**MONITORING YEAR 1
ANNUAL REPORT**
Final

LYON HILLS MITIGATION SITE

Subject: Lyon Hills Mitigation Site – Monitoring Year 1 Draft Report
Yadkin River Basin – CU# 03040101
Wilkes County
DMS Project ID No. 100085
Contract # 7620

On January 14, 2022, Wildlands Engineering received comments from the North Carolina Division of Mitigation Services (DMS) regarding the Draft Monitoring Year 1 Report for the Lyon Hills Mitigation Site dated December 3, 2021. The following letter documents DMS feedback and Wildlands' corresponding responses and revisions to the Monitoring Year 1 Report.

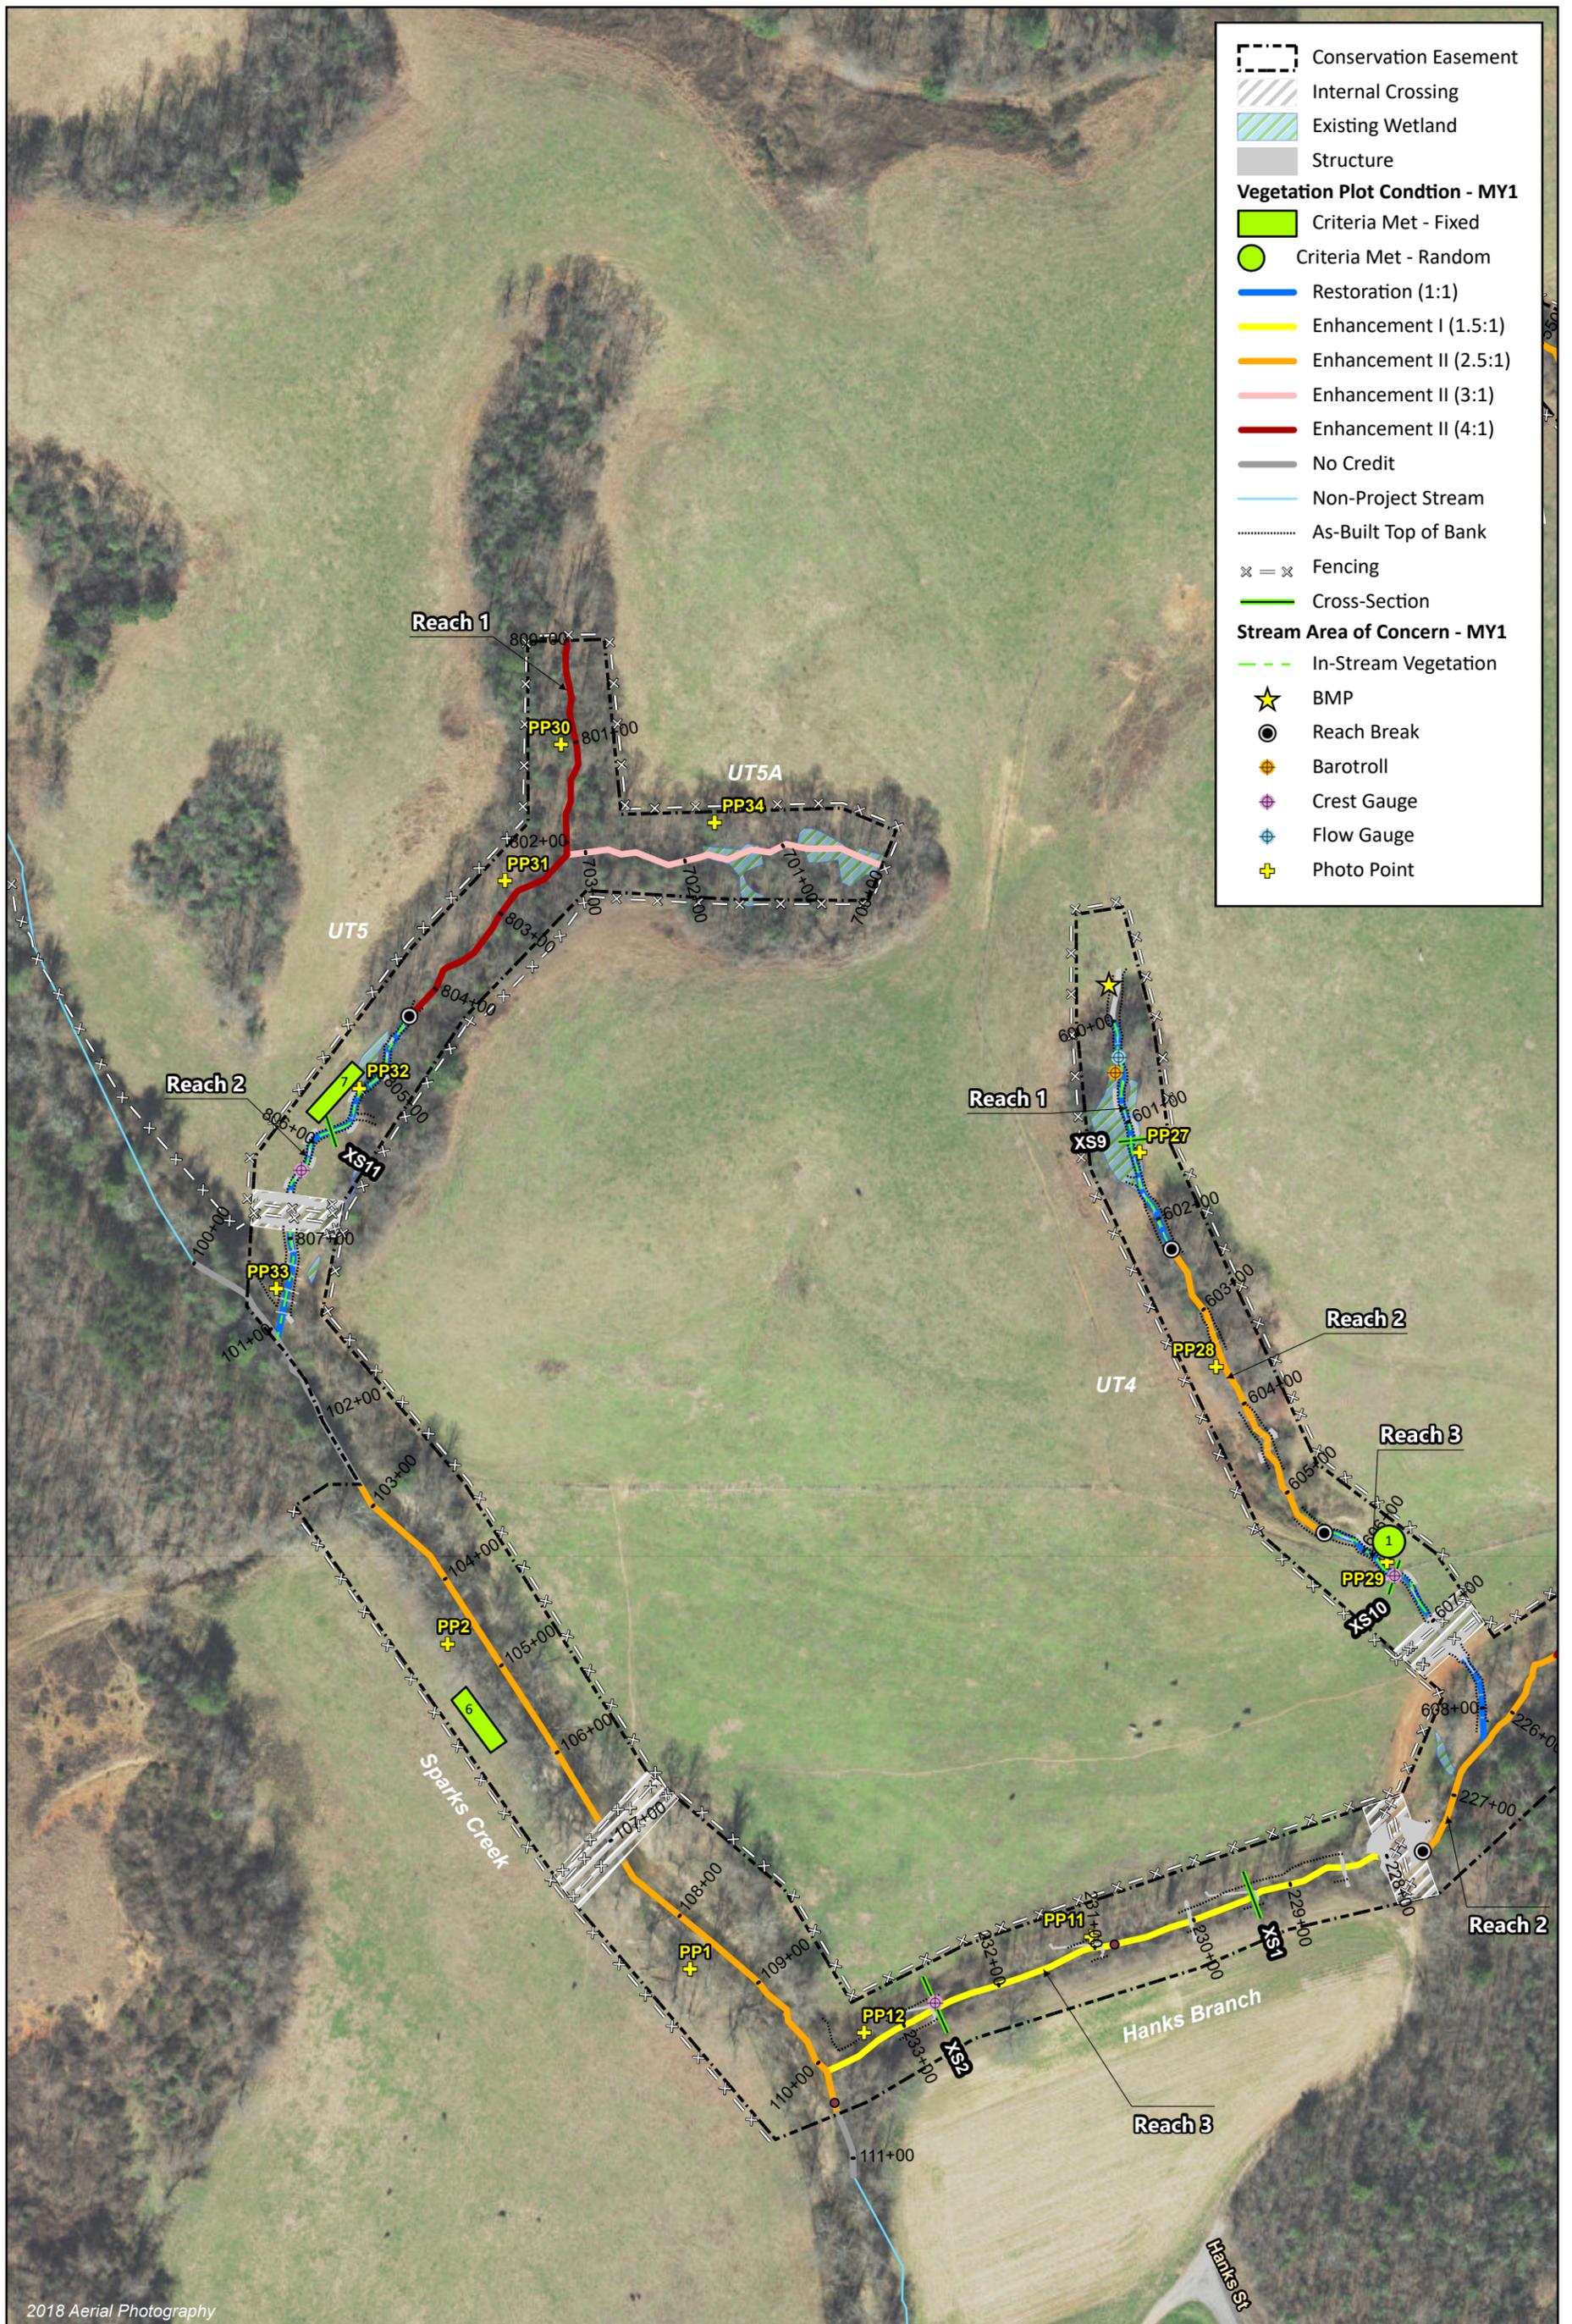
Section 2.4 Stream Areas of Concern: Indicate the current status of the sediment source that caused the aggradation along UT5. Did the pond function as a sediment sink and is the sediment source adequately controlled?

Response: A statement has been added addressing the sediment source.
